विषय:- वाशिम-दस्तापुर-कारंजा NH-१६१ (E) रस्त्याकरीता ०.७२ हे. वनजमीन वळतीकरणाच्या प्रस्तावास केंद्र शासनाकडील तत्वत: मान्यता पत्रातील अट क्रमांक-XI नुसार वन्यजीवाचे जाण्या-येण्या करीता भुयारी मार्ग (under pass) चे बांधकाम करणे शक्य आहे किंवा कसे ? याबाबत व वन्यजीवाचे आपघात टाळण्यासाठी इतर काही उपाययोजना करता येईल याबाबतची चर्चा करणे करीता तांत्रिक समितीची दिनांक-२९/०३/२०२३ रोजीच्या आयोजीत सभेचा कार्यवृत्तांत.

विषय:- वाशिम-दस्तापुर-कारंजा NH-१६१ (E) रस्त्याकरीता ०.७२ हे. वनजमीन वळतीकरणाच्या प्रस्तावास केंद्र शासनाकडील तत्वतः मान्यता पत्रातील अट क्रमांक-XI नुसार वन्यजीवाचे जाण्या-येण्या करीता भुयारी मार्ग (under pass) चे बांधकाम करणे शक्य आहे किंवा कसे ? याबाबतचा अहवाल.

Technical reasons for non-exaction of wild life under pass and Proposed Safety Measures

सहपत्र:- वनलांबोतील रस्त्याचा समजुतीचा नकाशा (प्रस्तावित सुरक्षा उपाययोजनांसह)

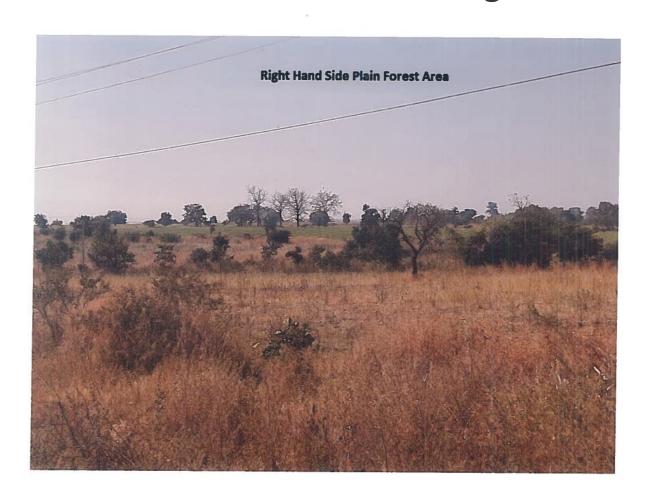
या विभागाकडून सदर महामार्गाच्या वनलांबीतील रस्त्याचा समजुतीचा नकाशा सादर करण्यात आला व त्यावर दर्शविलेल्या सुरक्षा उपाय योजनांवर सकारात्मक चर्चा करण्यात आली. संयुक्त पाहणीच्या वेळी असे निर्दशनास आले की महामार्गाची वनलांबी २४० मी. सोडून शेतक-यांनी महामार्गास लागून त्यांचे शैतौंला चारिह बाजूने चैन लिंक / तारेचे कुंपण केलेले आहे. सदर महामार्गाच्या वनलांबीत सादर केलेल्या समजुतीच्या नकाशा नुसार वन्यप्राण्यांच्या सुरक्षेकरिता सध्या अस्तीत्वात असलेल्या व प्रस्तावित सुरक्षा उपाय योजनांबाबत वनविभागाच्या वरीष्ठ अधिका-यांना अवगत करुन त्यांचे दालनात एकत्रीत सभा घेण्याचे ठरले व त्यांप्रमाणे वनविभागाच्या वरीष्ठ अधिका-यांच्या निर्देशा प्रमाणे पुढील कार्यवाही करण्याबाबत संयुक्त पाहणीचे वेळी निश्चित करण्यात आले.
